Meridian Ranch Fieldhouse Traffic Impact Study (LSC #S234410) February 8, 2024

LSC Responses to Meridian Ranch Fieldhouse TIS Redlines 3-14-24

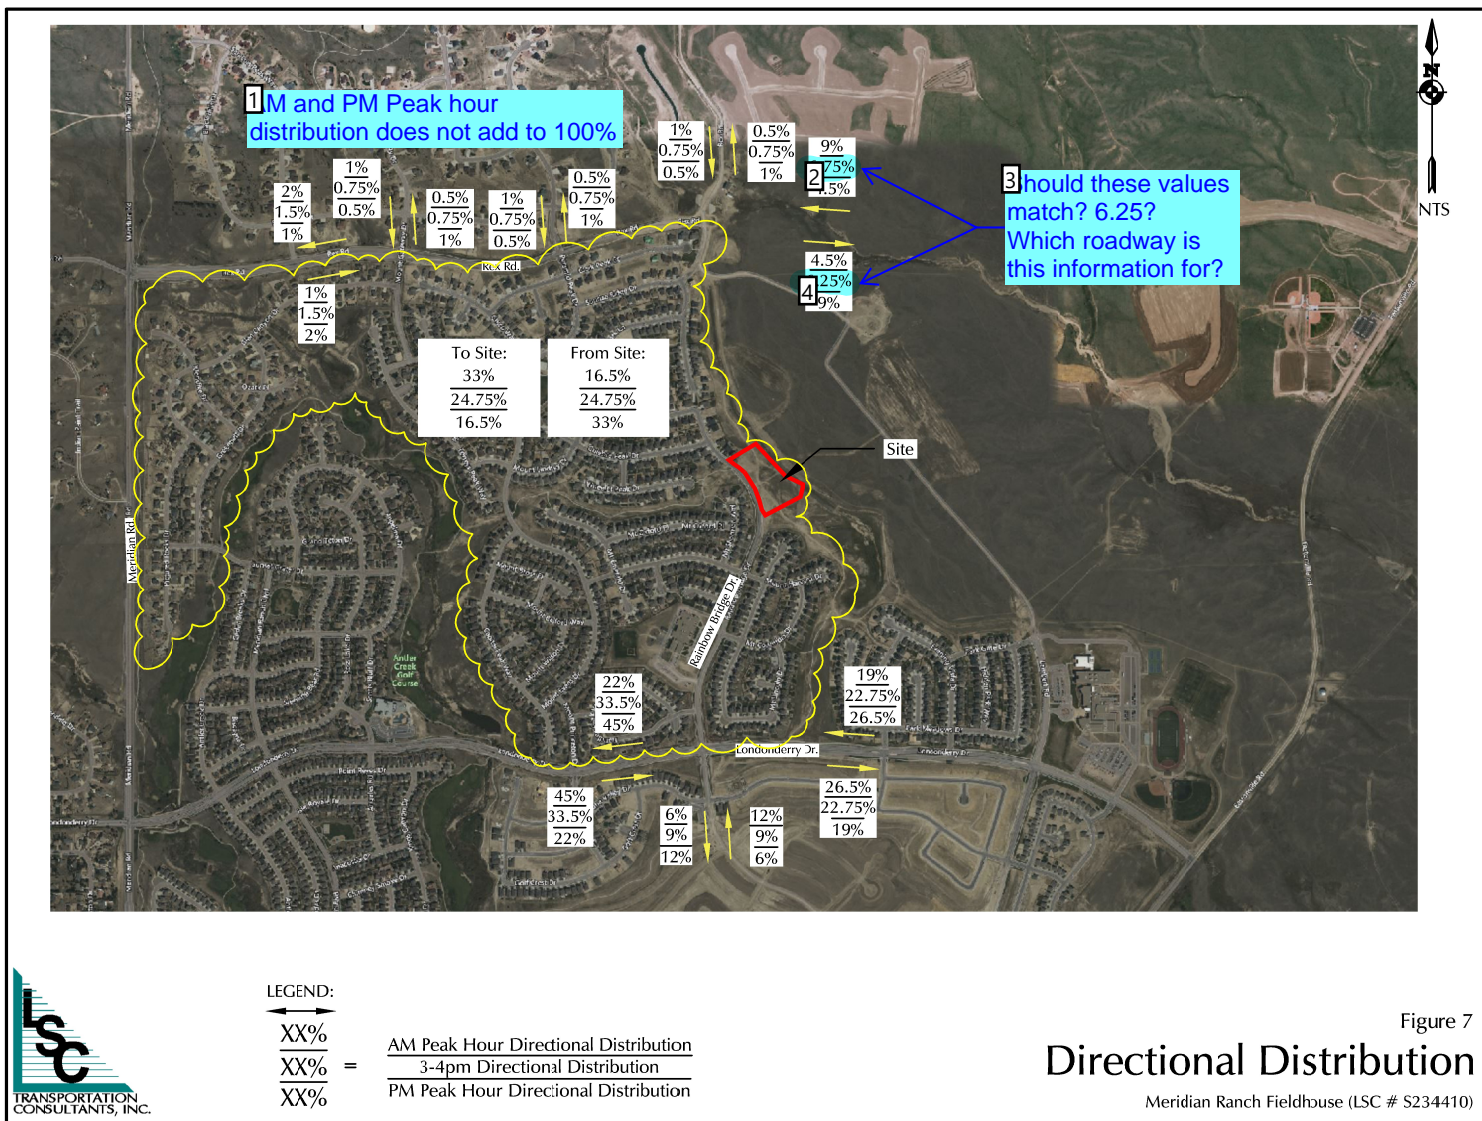
Number: 1 Author: Bret Subject: Engineer Date: 3/4/2024 17:33:09 -07'00'

AM and PM Peak hour distribution does not add to 100%

Should these values match? 6.25? Which roadway is this information for?

LSC Response: Typographical errors on the figure have been corrected.

LSC Response: Typographical errors on the figure have been corrected.
